Approval Sheet

PART NO.: SA130D-24U (replace 69-797-86)

DESIGN NO.: A130D15402-2

CHANGE NOTICE

REV.	DESCRIPTION				DATE/REVISER	DWG. NAME	DC CORD
DRAWER	DESIGN	CHECK	APPROVED	DIMENSION TOLERANCE	Q'TY	MODEL	MATERIAL
				0 ~ 5 ±0.1	UNIT		
				5 ~ 60 ±0.2	SCALE		P.V.C.
				60 ~ 200 ±0.3	ORIG. DATE		S89-C3GXX2-0Z%
				200 ~ 350 ±0.6	MANUFACTORY		
HN					2015.10.23

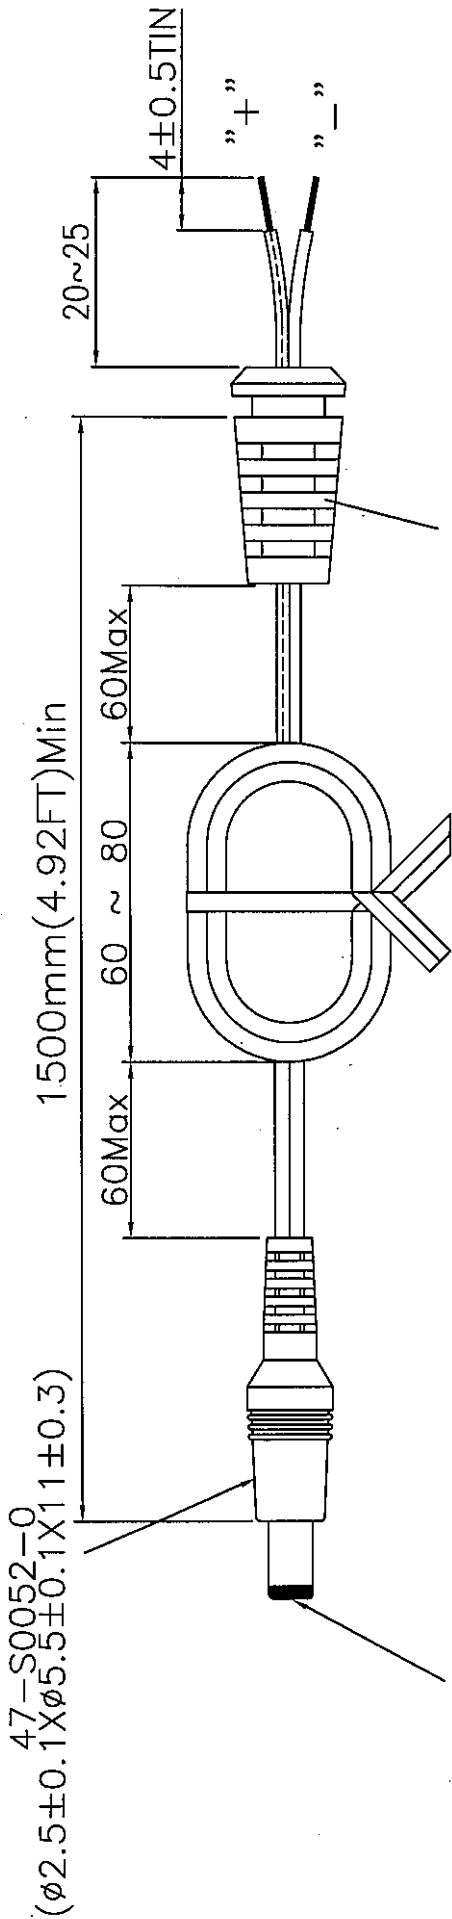
REMARK: change dc plug size to 5.5x2.5x11mm
 change to UL2468 wire

ORIGINAL DESIGN NO. A130D15402-1	REVISED DESIGN No. : A130D15402-2
<p>DC CORD :</p> <p>UL 1185 AWG18 80°C</p>	<p>DC CORD :</p> <p>UL 2468 AWG20*2C</p> <p>Customer Approved by :</p>

REV.	DATE	BY:	DESCRIPTION OF CHANGE
-2	29-Oct-15		Change the DC CORD;
Designed by : 陳鳳	Checked by : //	Approved by : 李福靜

8-3 Output Cable : 1500mm UL2468 AWG20*2C , with Plug : 2.5*5.5*11 S
Polarity : Center "+"

UL 2468 AWG20*2C
